Rezoning Transportation Analysis

Petition Number: 2020-046

General Location Identifier: Tax ID 20103128

Date	Description
04-21-20	First Review

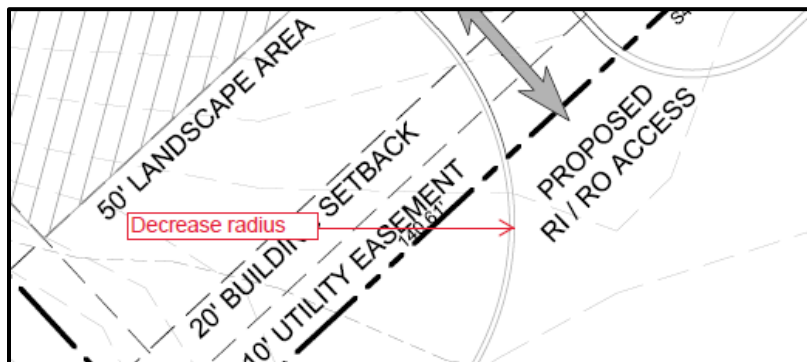
- Traffic Study** A Traffic Impact Study is not necessary for the complete review of this petition.
- The petitioner should revise the site plan and conditional note(s) to commit to dedicate a minimum of 35 feet of right-of-way from the Whitehall Park Drive road centerline, per the Chapter 12 Zoning Ordinance requirements for a minor thoroughfare. The site plan should label and dimension the right-of-way from the road centerline.
- The petitioner should revise the site plan and conditional note(s) to preserve the existing driveway as right-out only. Per NCDOT, a right-in/right-out driveway will affect the functionality of the intersection. Please provide CDOT with any other correspondence that the petitioner has had with NCDOT, since plans to convert this access to right-in/right-out were already submitted to the city for permitting review within Accela: LDC-2019-00062 - Leon Whitehall.

- In reference to the Urban Street Design Guidelines (USDG), CDOT recommends the petitioner to revise the site plan and conditional note(s) to decrease the Tryon right-out only radius for a SU-30 vehicle only, using Condition D of Appendix C of the USDG.
